Cover Note – Non Material Amendment to PL/2022/09425 – Land at Elm Grove Trowbridge – February 2026

This note sets out the reasoning and justification for non-material amendments being sought to the above reserved matters (RM) approval.

The application requests the substitution of approved plans to reflect changes necessary to the scheme following a detailed review of engineering details, specifically in relation to the design and location of the sub-station, the underground elements of the pumping station and minor amendments to private driveways.

The extract below shows how the pump station and substation have been repositioned to fit within the registered title (green land)

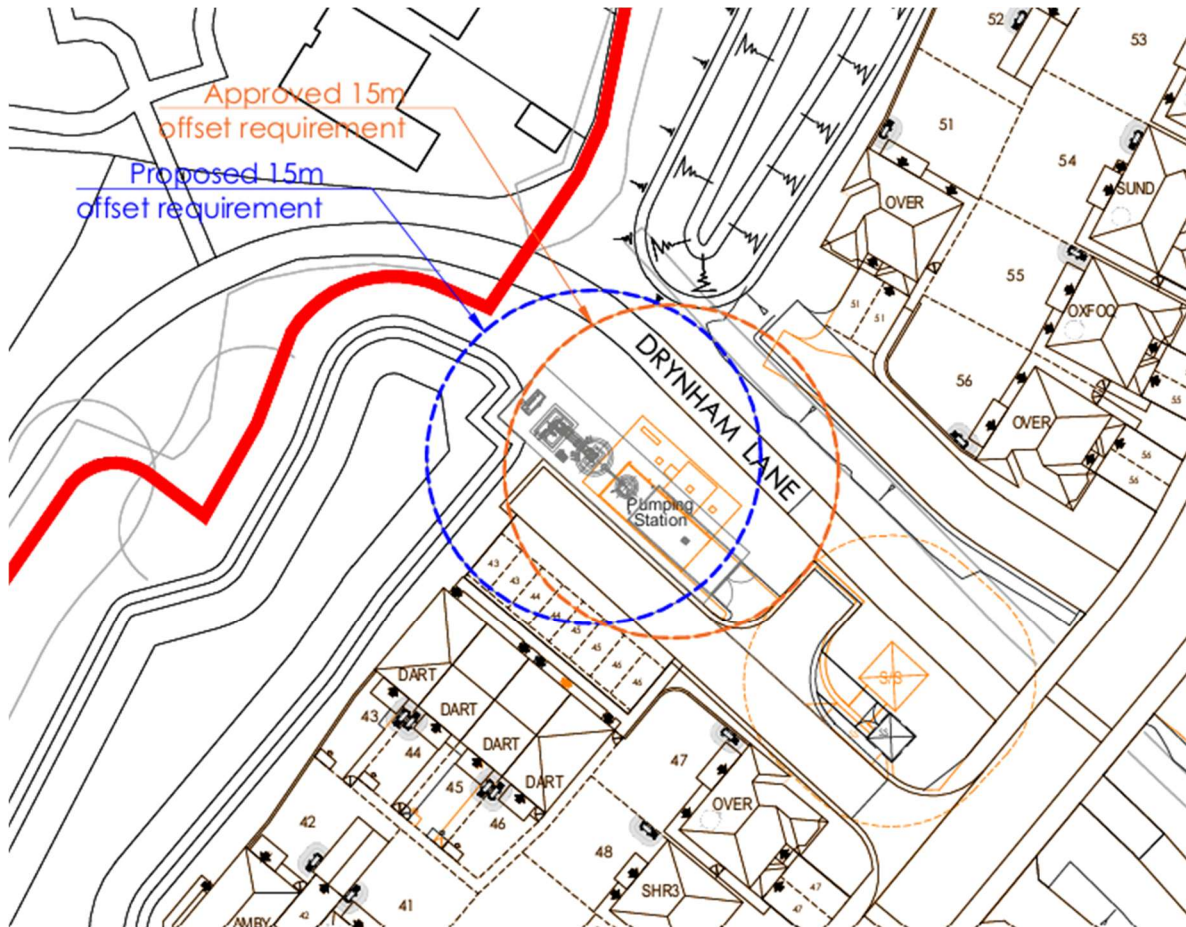
Through the development of the detailed design and implementation of the foul sewerage pumping station and substation for the development. Our legal searches found that the previously approved position on the development straddles a section of unregistered land that sits besides Drynham Lane in this area. It is a requirement of both pieces of infrastructure that they are transferred to their adopting authority. The presence of the unregistered land within the footprint of each element would have prevented this.

The pump station arrangement has needed to be elongated, and as such a very minor encroachment into the attenuation basin has been required. We include associated calculations and a statement from JRC to demonstrate this encroachment has no material impact on the performance of the attenuation basin or storage capacity.

The title issue means that we have needed to make minor amendments to the position and layout of these assets as shown on the new plans. In order to fit the substation in the allowable space, it needs to be reduced in its footprint. Due to the limits on available footprint and the need maintain a minimum distance to the proposed residential properties, the external appearance has had to change from the approved brick to GRP. There isn't sufficient space to house the sub-station in brick work.

Changes to Sub Station and Pumping Station

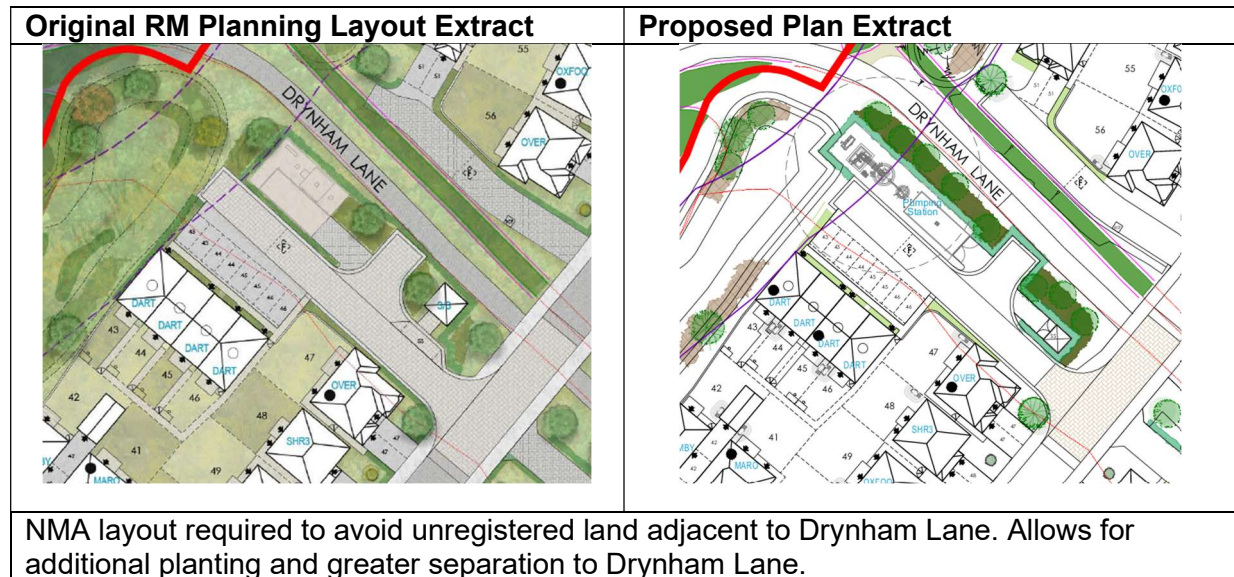
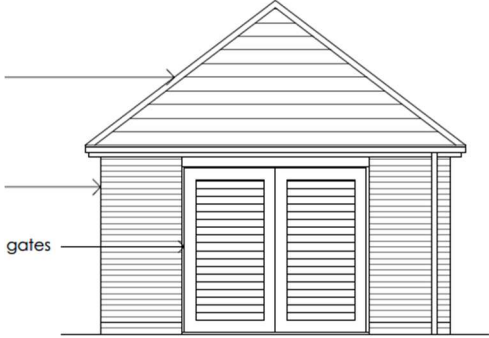
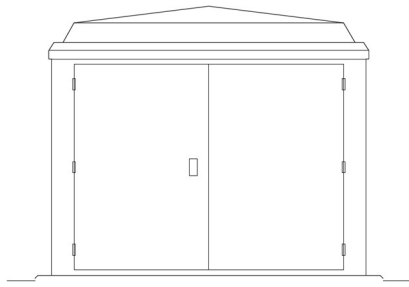
Substation materials revised to GRP (Green) – needed to fit in to smaller available footprint – mitigated through additional planting.

Change to Driveways

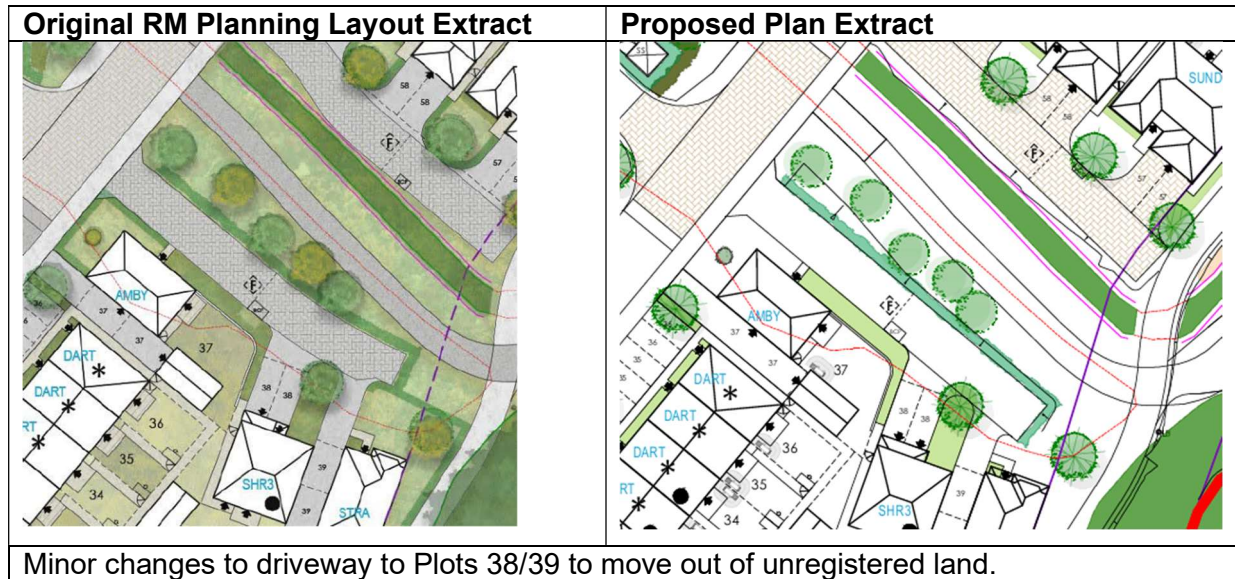
Minor changes to driveway to Plot 51 to move out of unregistered land.
